# Access Compliance Report

## Public Rights-of-Way

Intersection ID: 50470	Main Street: EVERTON_DR	Cross Street: LENOX_POINTE_DR	Location: SW
ADA ID: 7E6B5A182FAC	Ramp Type: Perp	Initial Pass/Fail: Fail	Overall Compliance: No
		Severity Score: 12.5

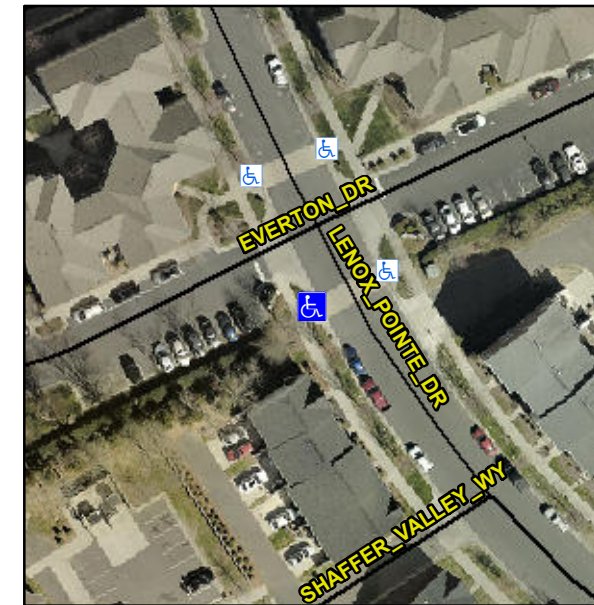
**Not Found, R304.2.2**

Compliance	Description	Data	Compliance	Description	Data
N/A	Ramp Length (in)	85.0	No	Ramp Slope (%)	9.3
Yes	Ramp Width (in)	48.0	Yes	Ramp XSlope (%)	0.4
N/A	Flare Type LT	N/A	N/A	Flare Type RT	N/A
N/A	Flare Slope LT (%)	N/A	N/A	Flare Slope RT (%)	N/A
N/A	Flare Traversable LT?	N/A	N/A	Flare Traversable RT?	N/A
N/A	Landing Length (in)	N/A	N/A	DWS Provided?	N/A
N/A	Landing Width (in)	N/A	N/A	DWS Contrast?	N/A
N/A	Landing Slope (%)	N/A	N/A	DWS Length (in)	N/A
N/A	Landing X Slope (%)	N/A	N/A	DWS Full Width?	N/A
N/A	Landing Curb? (Y/N)	N/A	N/A	DWS Offset (in)	N/A
N/A	Shared Landing?	N/A			
N/A	Gutter Ponding?	N/A	N/A	Gutter Slope (%)	N/A
N/A	Gutter Lip Ht (in)	N/A	N/A	Gutter X Slope (%)	N/A
N/A	Painted X Walk1?	Yes	N/A	Painted X Walk2?	N/A
	X Walk 1 Direction	To E		X Walk 2 Direction	N/A
N/A	X Walk 1 Width (in)	144.0	N/A	X Walk 2 Width (in)	N/A
	X Walk 1 Slope (%)	0.5		X Walk 2 Slope (%)	N/A
	X Walk 1 X Slope (%)	2.4		X Walk 2 X Slope (%)	N/A

**Remove & Replace Entire Ramp.**
